City of Portland, Maine - Building or Use Permit Application 389 Congress Street, 04101, Tel: (207) 874-8703, FAX: 874-8716 Location of Construction: Owner: Phone: Permit No: (207) 874-6399 Richard R. & Ellen J. Farnsw 04102 Portland '55 Gld Mast Rd. Owner Address: Lessee/Buyer's Name: Phone: BusinessName: Portland MS Old Mast Rd. Permit Issued Contractor Name: Address: Phone: 04102 (207) 1905 Bongress St. Portland Landpark Builders 1 8 1999 COST OF WORK: PERMIT FEE: Past Use: Proposed Use: \$ 2,700.00 Sincle Family \$ 35.00 FIRE DEPT. □ Approved INSPECTION: Use Group: BType 543 ☐ Denied BOCA 46 Zone: CBL: 2134014 Signature: Zoning Approval: Proposed Project Description: PEDESTRIAN ACTIVITIES DISTRICT (P.A.D.) Action: Approved Special Zone or Reviews: Remodel Kitchen W/ Expansion Approved with Conditions: ☐ Shoreland Denied ☐ Wetland ☐ Flood Zone □ Subdivision Date: Signature: ☐ Site Plan maj ☐minor ☐mm ☐ May 12th, 1899 Permit Taken By: S.P. Date Applied For: **Zoning Appeal** □ Variance This permit application does not preclude the Applicant(s) from meeting applicable State and Federal rules. 1. ☐ Miscellaneous 2. Building permits do not include plumbing, septic or electrical work

FARNSWORTH,RICHARD 55 OLD MAST RD. PORTLAND, ME Scale : maximum

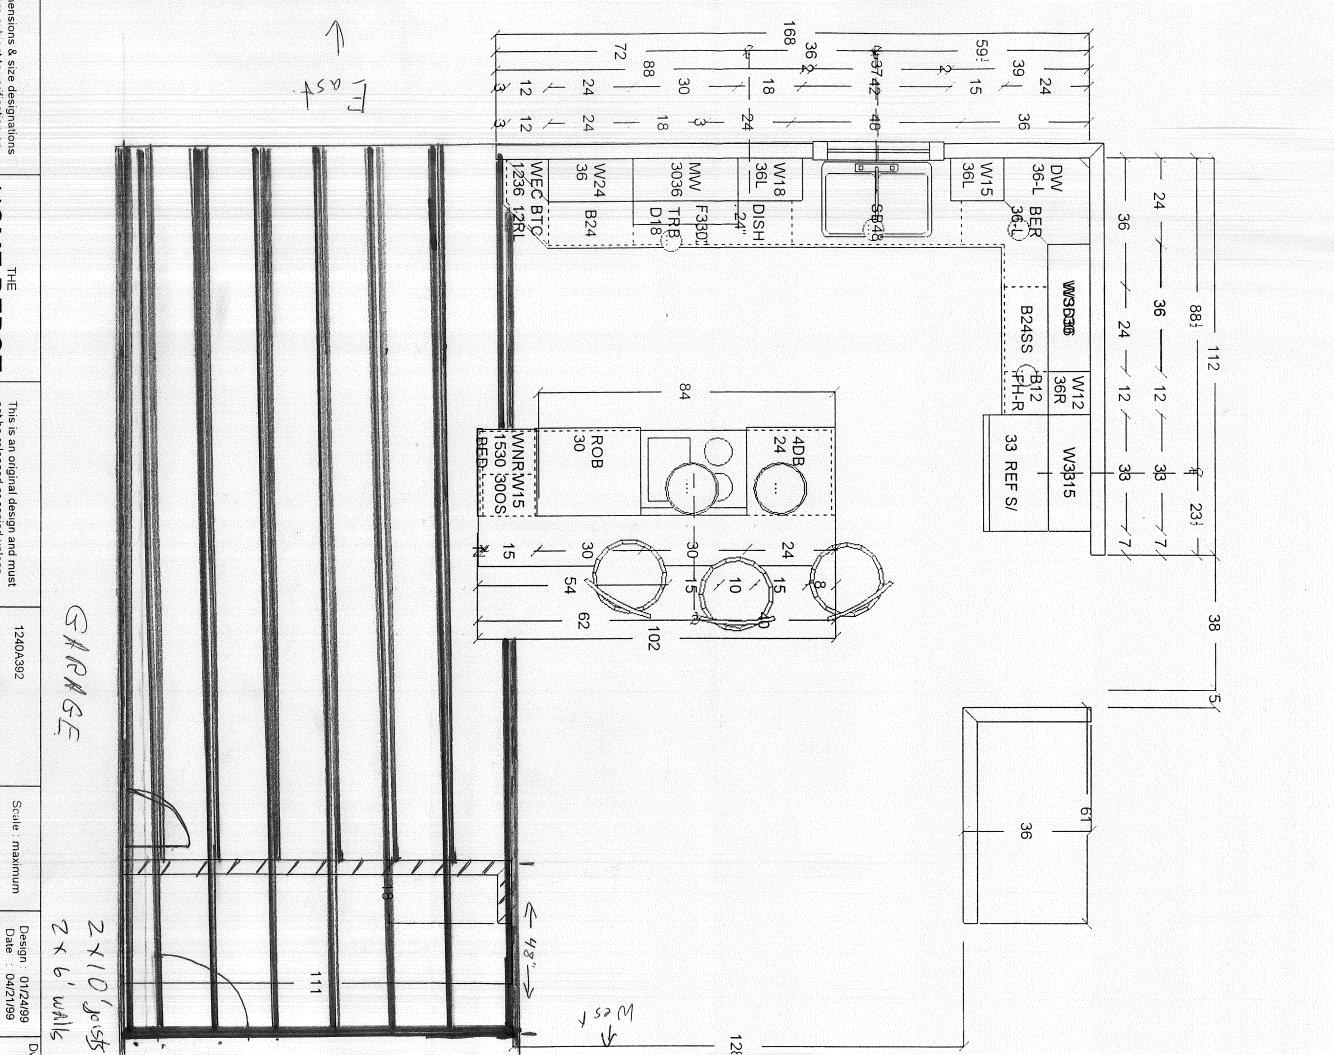
Note: customer called and wanted to cahge size of the wall from 98" to 112" he wanted a small cabinet and re order!!!
